The Secretary  
An Bord Pleanála,  
64 Marlborough Street,  
Dublin 1

21<sup>st</sup> October 2019

Re: **Proposed N6 Galway City Ring Road.**

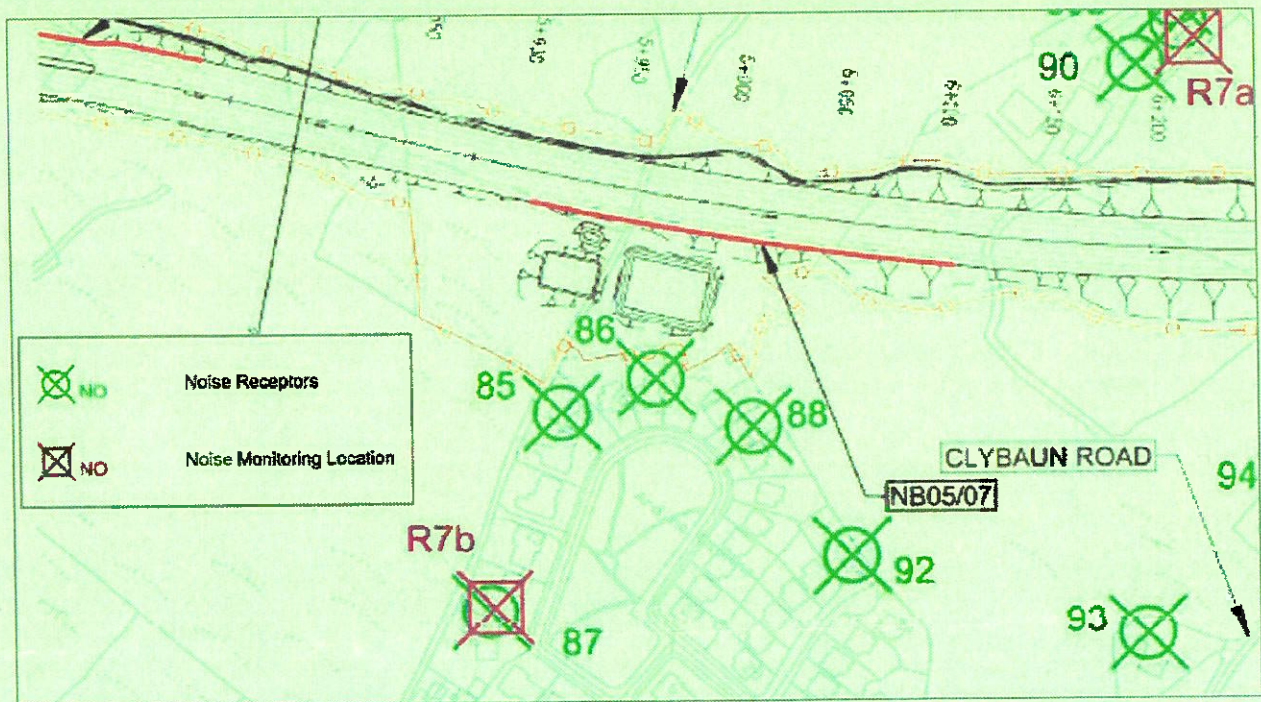
Once the development is completed, it will be necessary to monitor impacts. We note the position of the proposed noise monitoring location R7b (extract below). This is remote from the properties most impacted by the proposed development and not a reasonable basis on which to monitor impacts.
